MACK TRUCKS, INC
2100 MACK BOULEVARD
P O BOX M
ALLENTOWN, PA 18105-5000

SUBJECT: Vehicle Safety Recall - SC0318
Chalmers Suspension

Subject: Adjustable Torque Rod Replacement — Chalmers Rear Suspension

#20061110

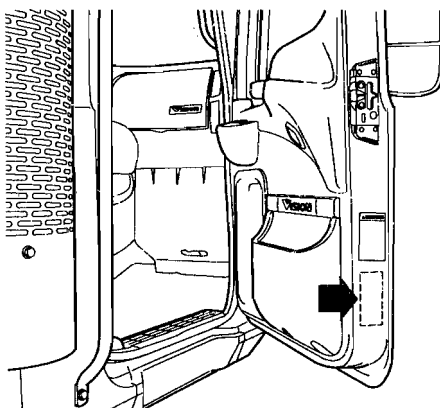
The torque rods on all affected chassis must be inspected. Suspect torque rods are identified by the lot numbers which are cast into the rod end castings on each end of the rod. Suspect lot numbers are as follows:

- 2056
- 2266
- 2406
- 2416
- 2426

Inspect both cast ends on each end of the torque rods per the instructions outlined in the attached Chalmers service bulletin No. 20061110. The lot number will be found on one side of the casting. If the lot number on the casting is listed above, the torque rod must be replaced.

When replacing the torque rod(s), tighten the bushing center bolts to 183 N•m (135 lb-ft). Check the thrust angle of each axle where the torque rod has been replaced, and adjust as necessary. Recheck thrust angle, and then tighten the torque rod pinch bolts to 183 N•m (135 lb-ft).

Figure 3

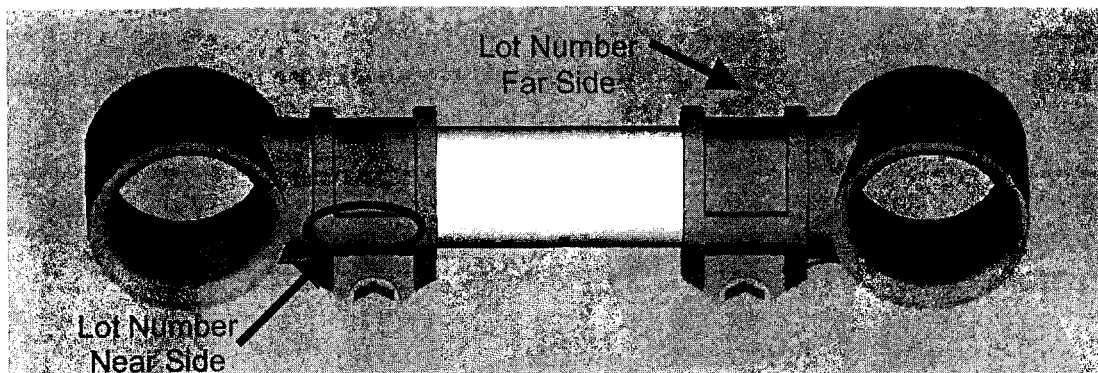
Typically, when inspecting an adjustable torque rod installed on a truck, the left side casting will have the Lot number on the near side and the right side casting will have the Lot number on the far side (See Fig. 3).
